### Utility Notes

### OLCC Warehouse

### September 12, 2024

## ODOT Formal Response

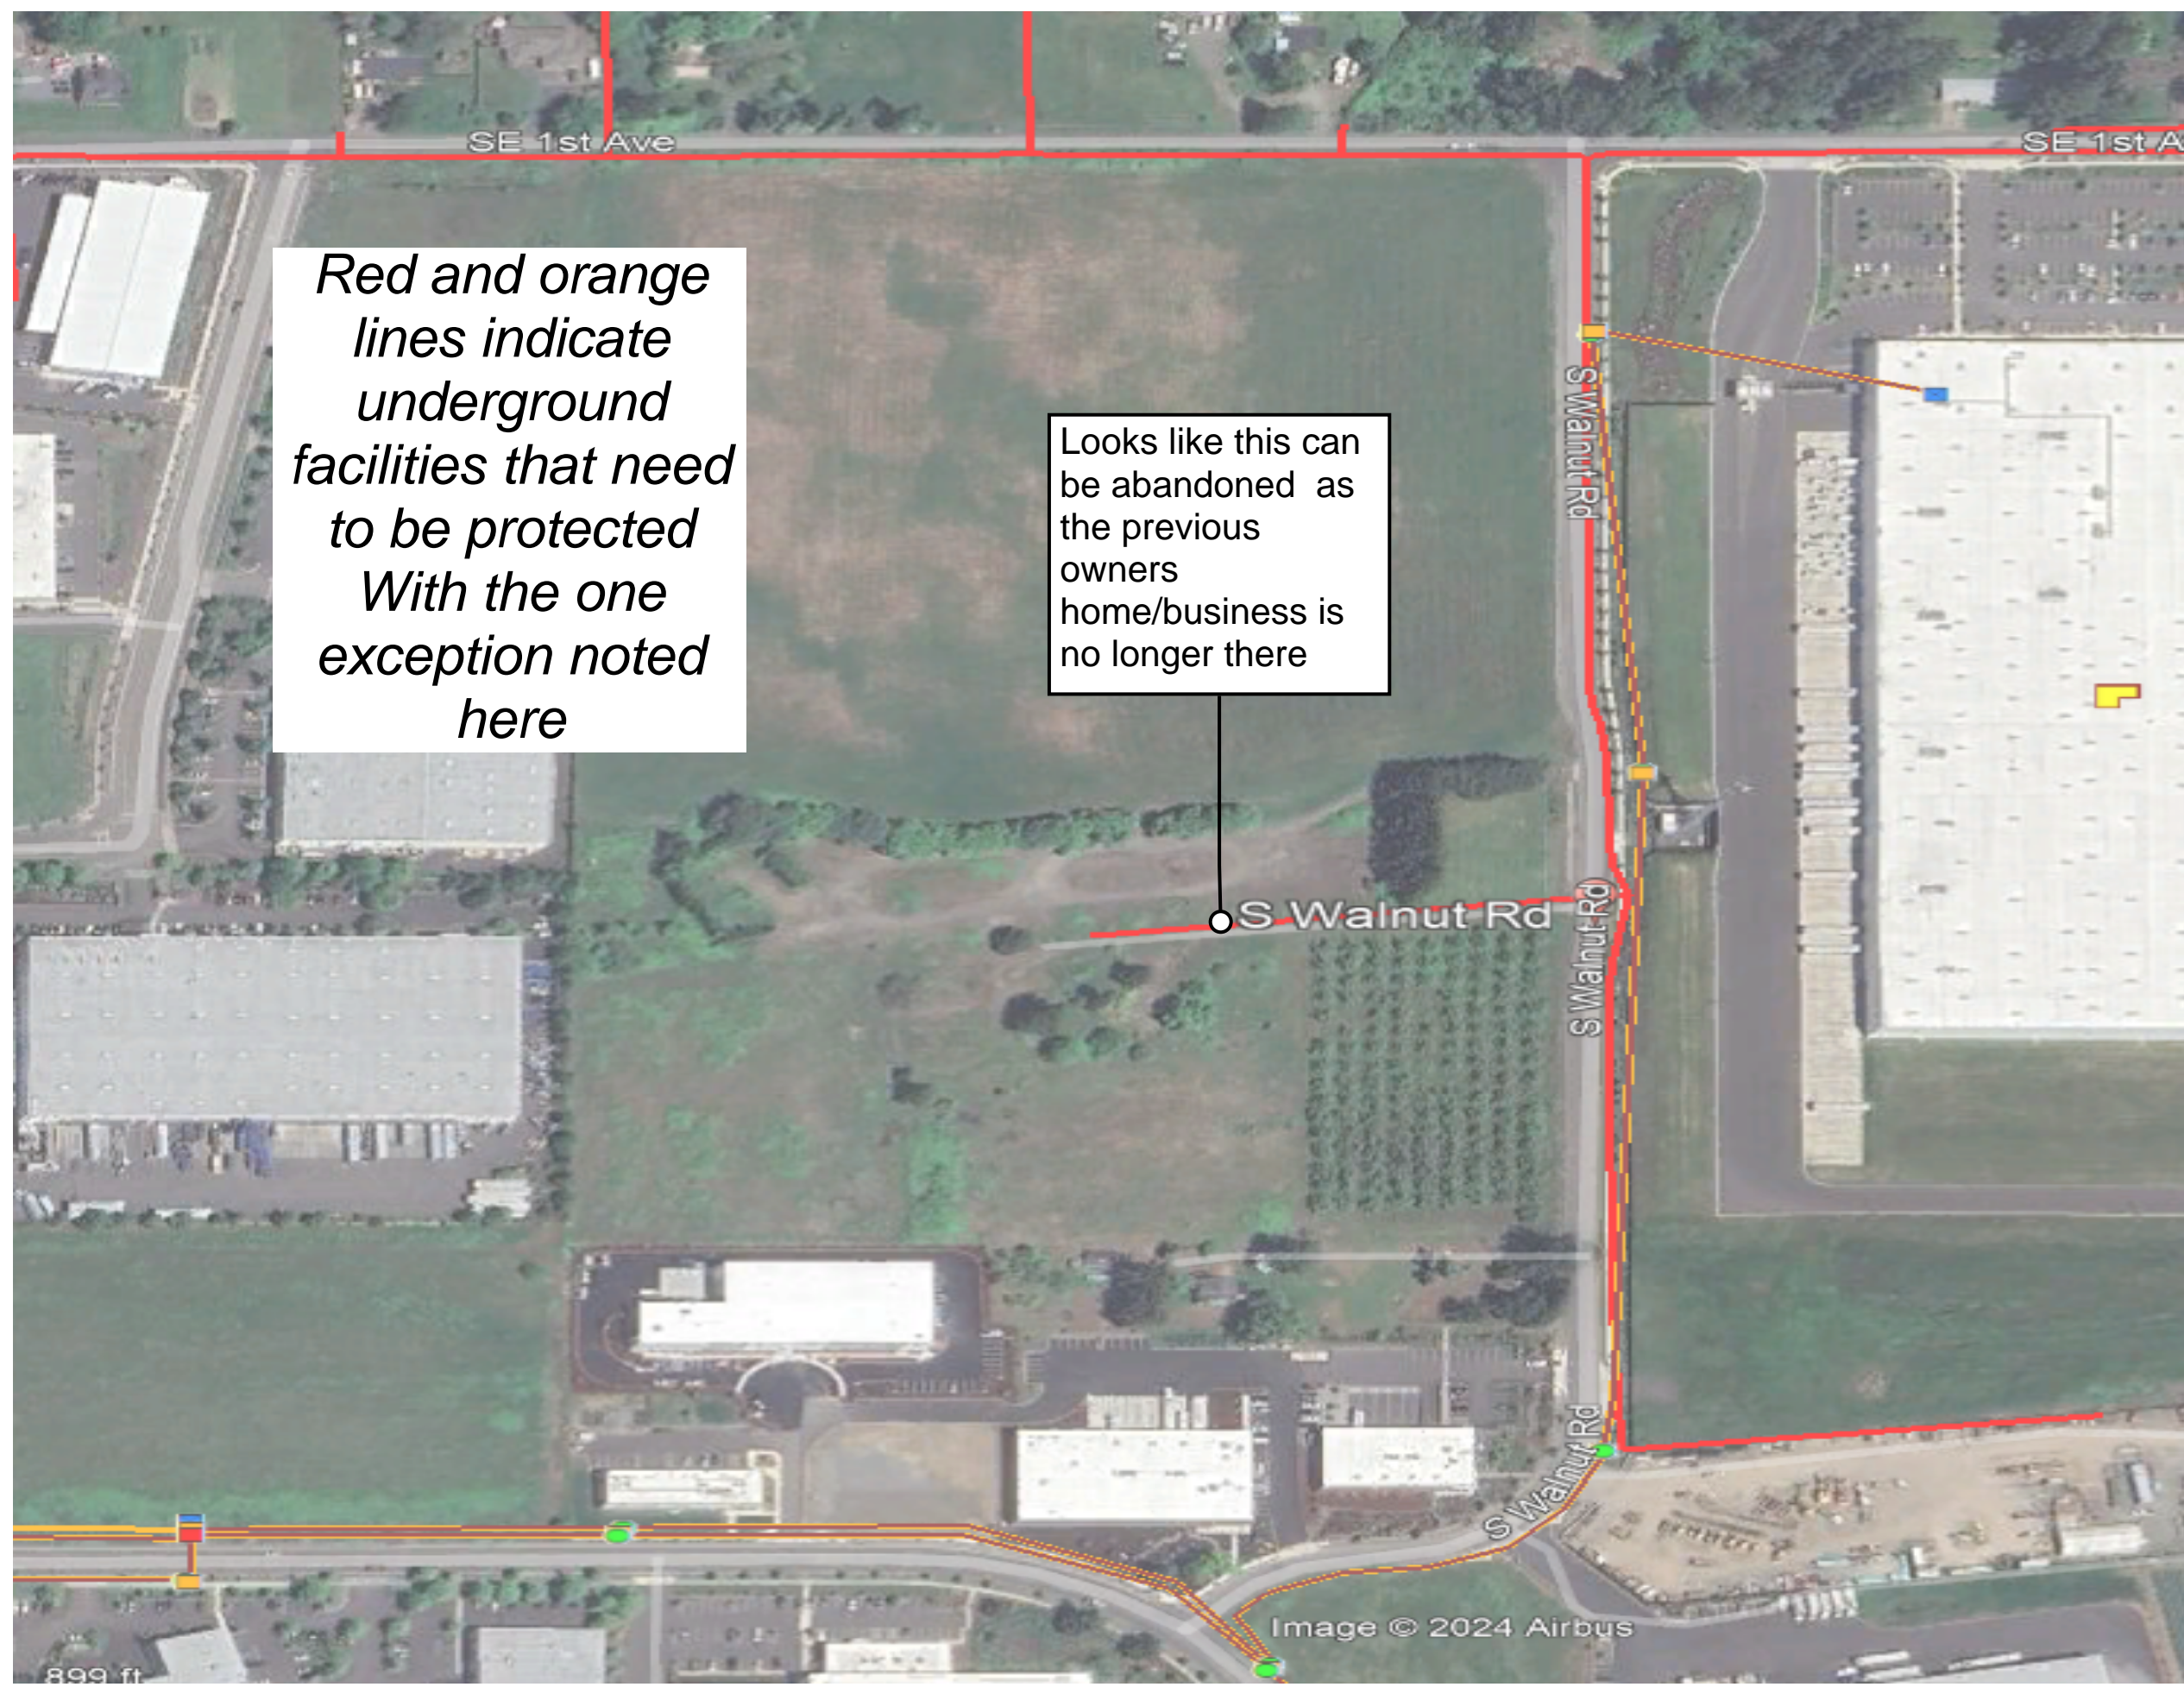
*Red and orange lines indicate underground facilities that need to be protected With the one exception noted here*

Looks like this can be abandoned as the previous owners home/business is no longer there
